ADDENDUM TO CONTRACT DOCUMENTS

Project: Tigard Senior Center
8815 SW O'Mara Street
Tigard, Oregon 97223

Project No. 207037

Addendum No: 2

A102-R1

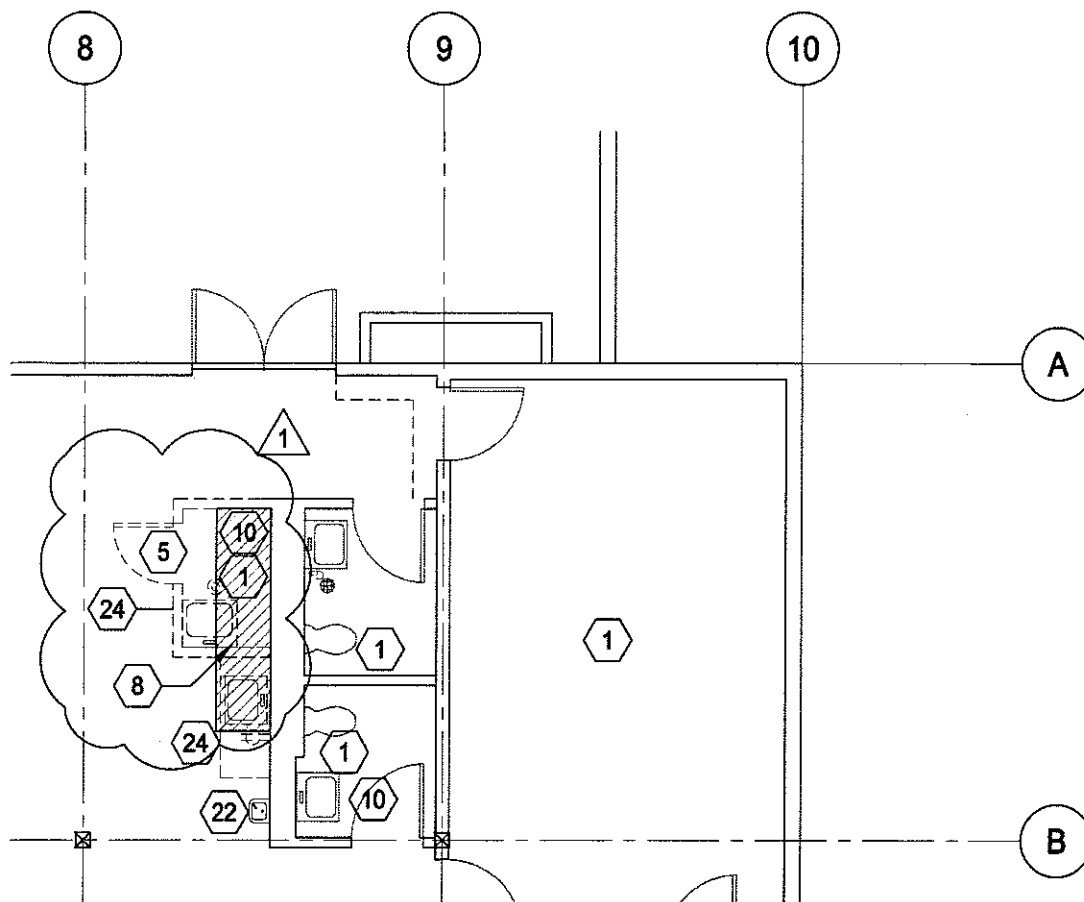
Revise: Drawing A102 as indicated in 8-1/2 x 11 inch Drawing A102-R1, dated 10-08-07, per attachment.

A201-R1

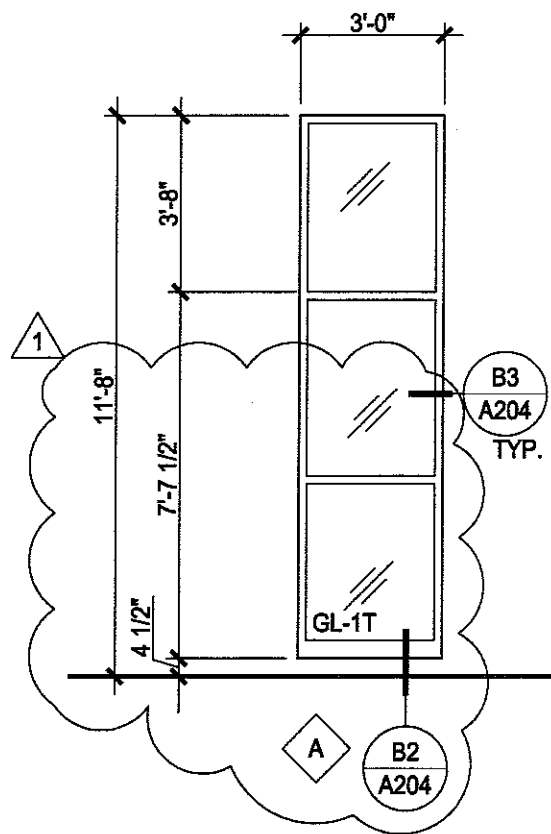
Revise: Drawing A201 as indicated in 8-1/2 x 11 inch Drawing A201-R1, dated 10-08-07, per attachment.

A203-R2

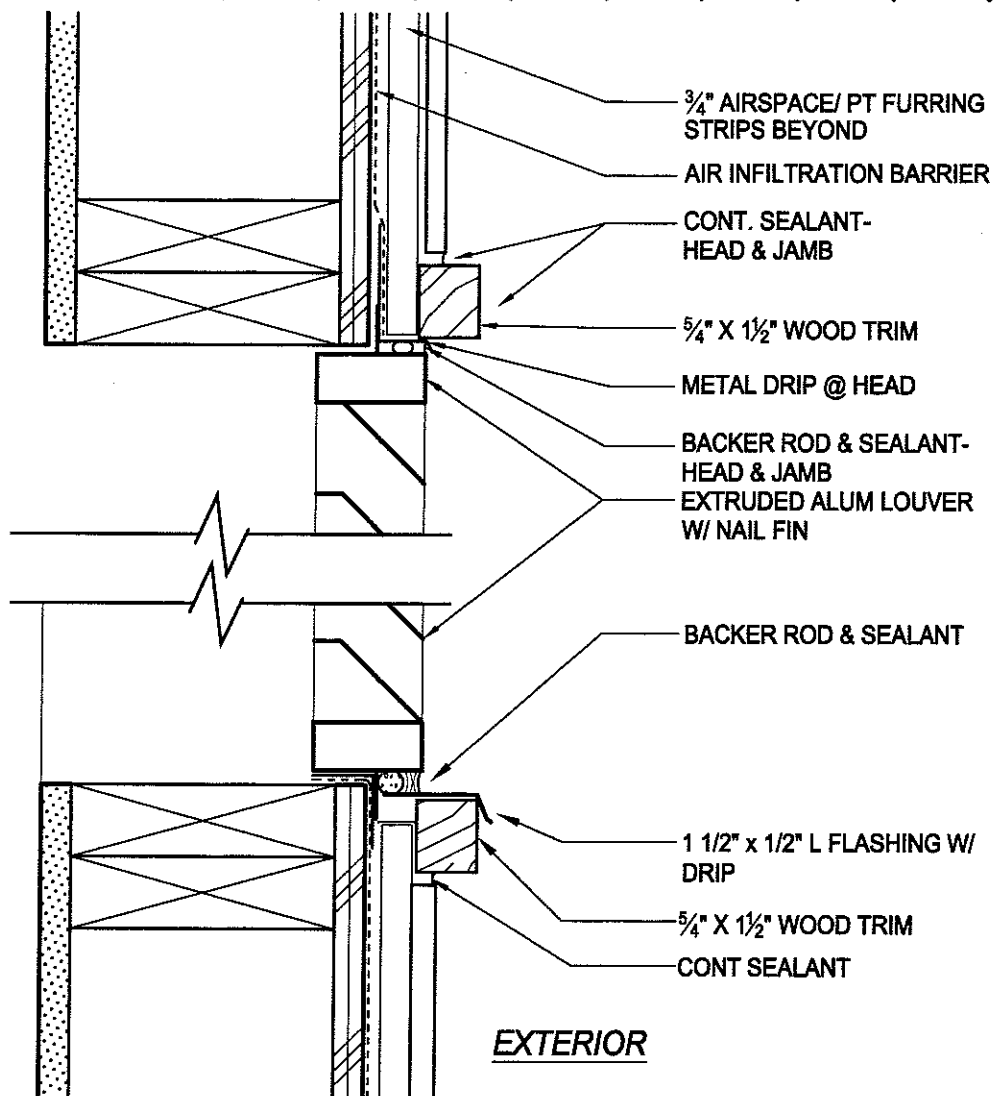
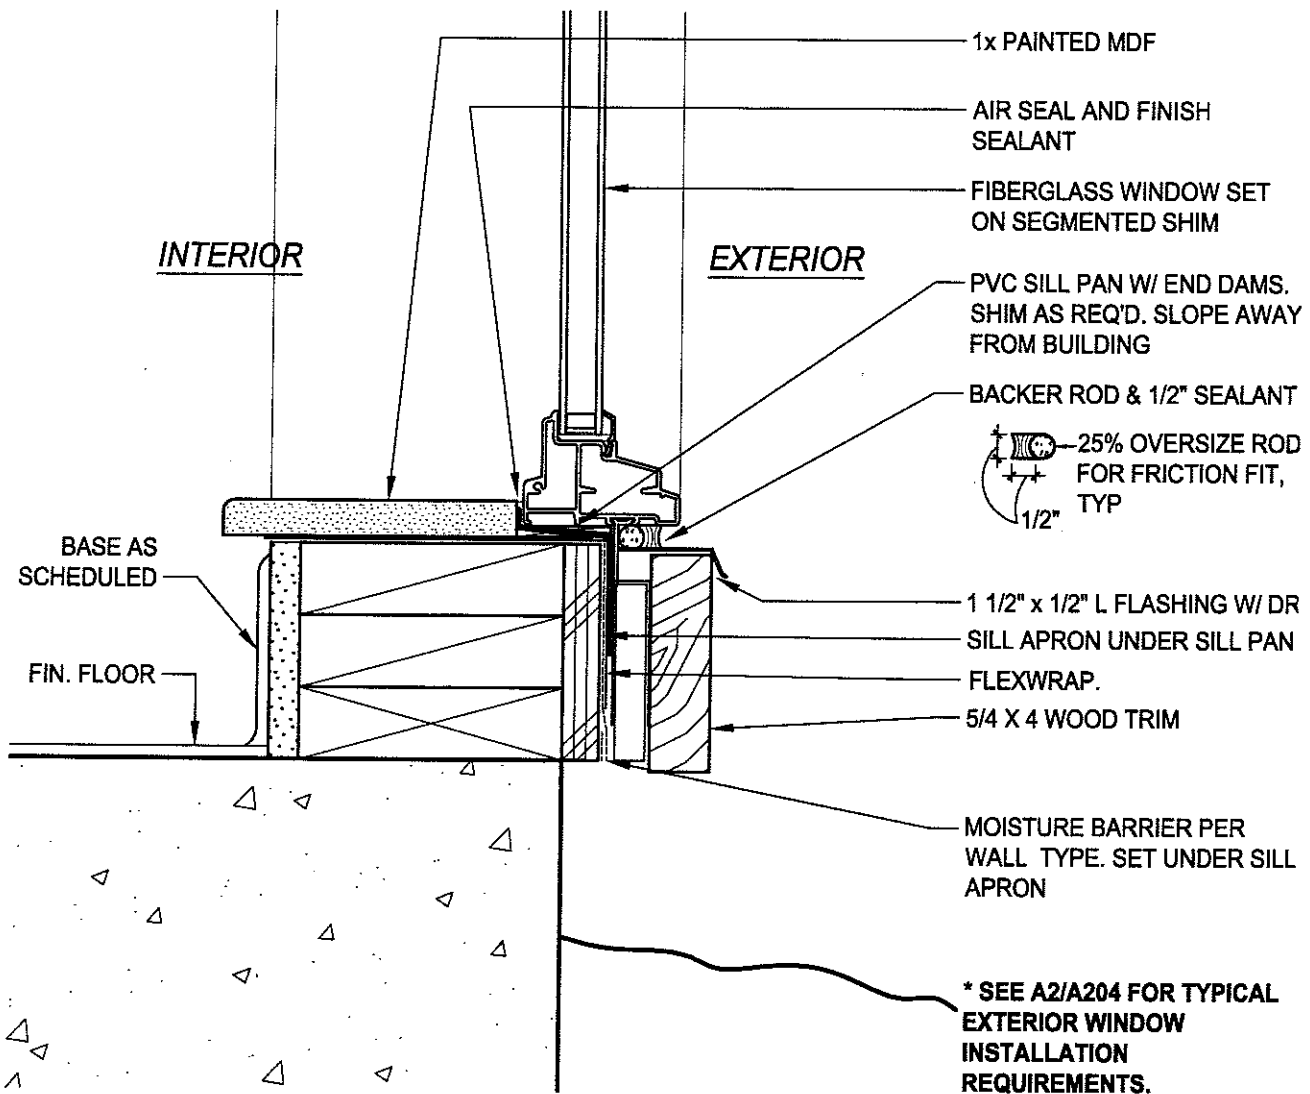
Revise: Drawing A203 as indicated in 8-1/2 x 11 inch Drawing A203-R2, dated 10-08-07, per attachment.

A401-R1

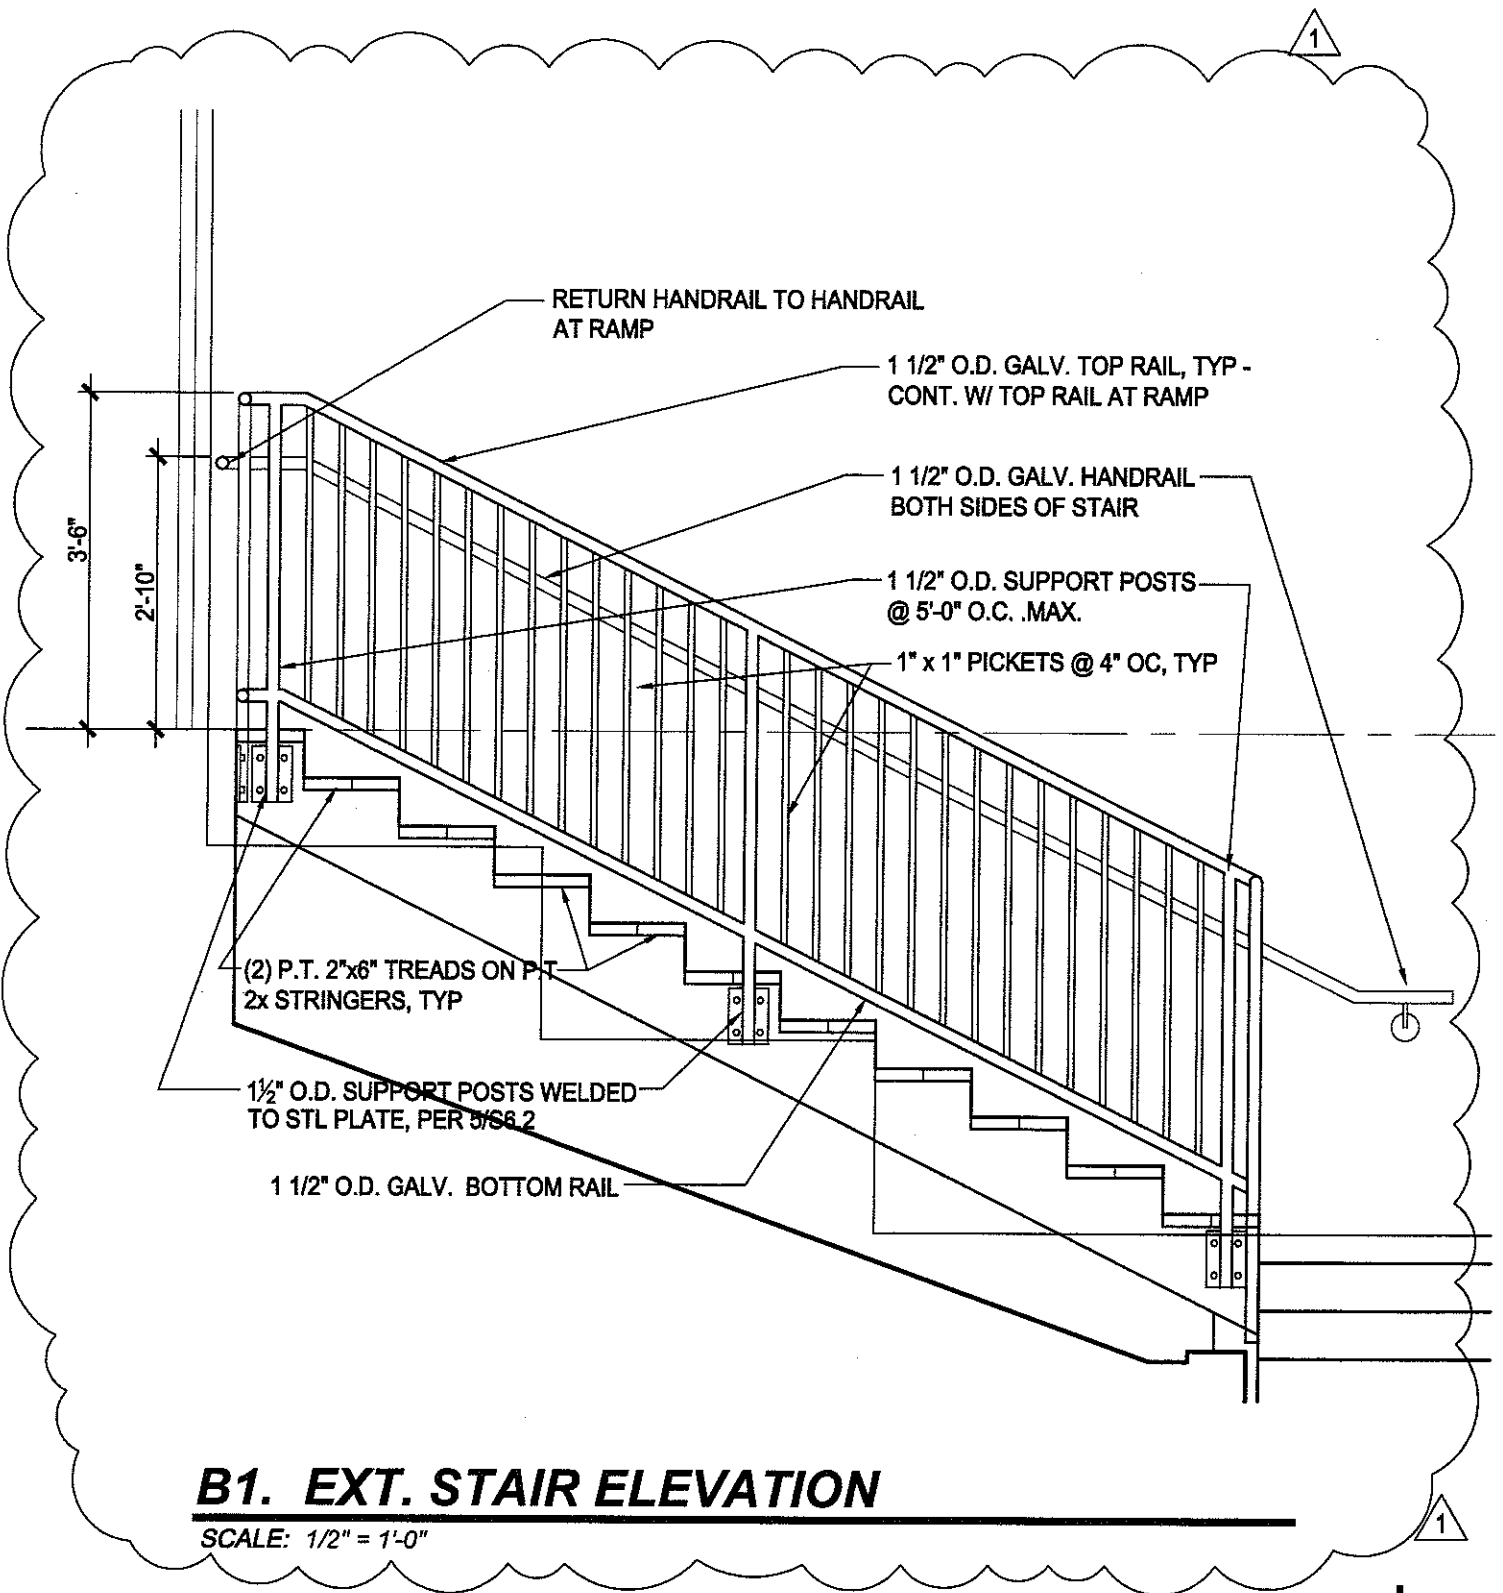
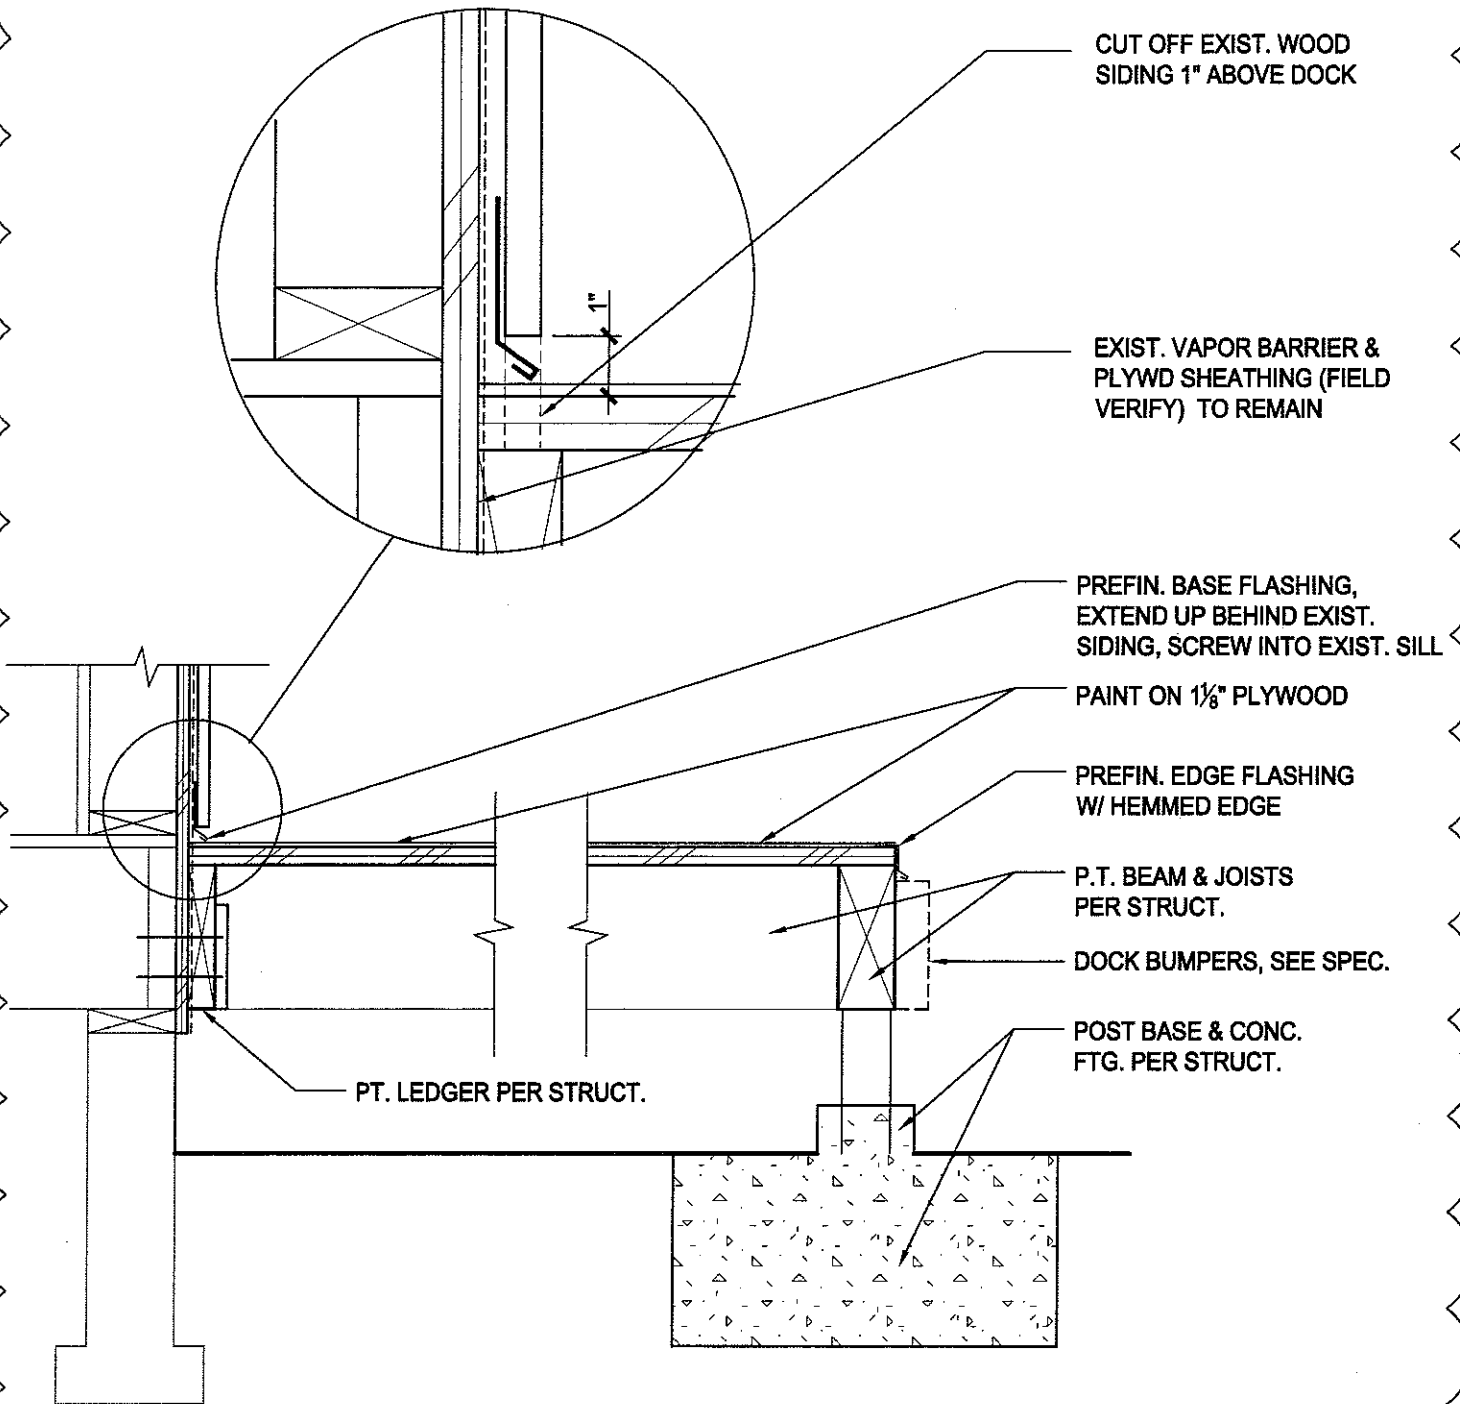
Revise: Drawing A401 as indicated in 8-1/2 x 11 inch Drawing A401-R1, dated 10-08-07, per attachment.

A603-R1

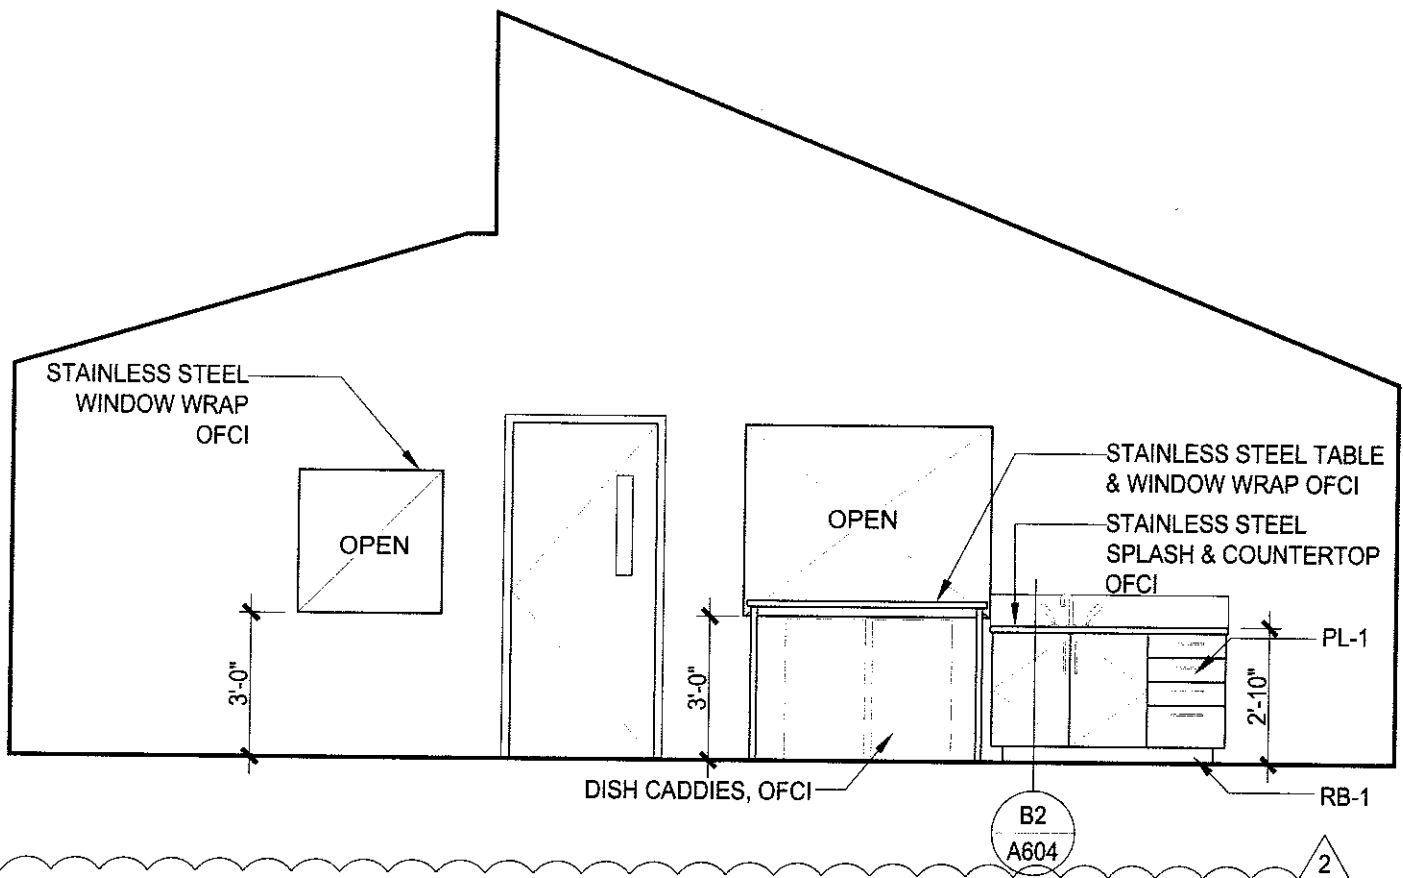
- Revise:** Drawing A603 as indicated in 8-1/2 x 11 inch Drawing A603-R1, dated 10-08-07, per attachment.
- Revise:** Drawing A603 as indicated in 8-1/2 x 11 inch Drawing A603-R2, dated 10-08-07, per attachment.
- Revise:** Drawing A603 as indicated in 8-1/2 x 11 inch Drawing A603-R3, dated 10-08-07, per attachment.
